ADDENDUM No. 1

REQUEST FOR QUOTATIONS No.:	1220-040-2023-030
TITLE:	SUPPLY AND DELIVERY OF 300MM WATERMAIN
ADDENDUM ISSUE DATE:	MAY 17, 2023
REVISED DATE:	PREFER TO RECEIVE SUBMISSION ON OR BEFORE MAY 25, 2023

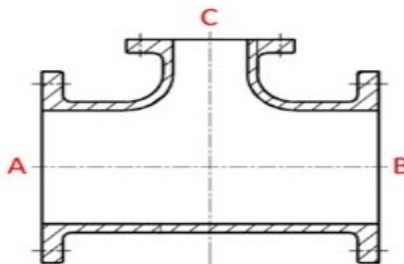
Q2. Please clarify the required tees noted in item #3 and #4 of Fees and Payments in Schedule B – Form of Quotation: provide sizes and end types for A x B x C per below.

Reading/describing a tee:

- A x B x C
- A to B is the through line.
- C is the branch.
- This is to be consistent for describing both the sizes and end types.

- A2. Item number 3: 300mm MJ x 300mm MJ x 150mm FL**
Item number 4: 300mm MJ x 300mm MJ x 150mm Hub (If Hub not available, can be MJ)
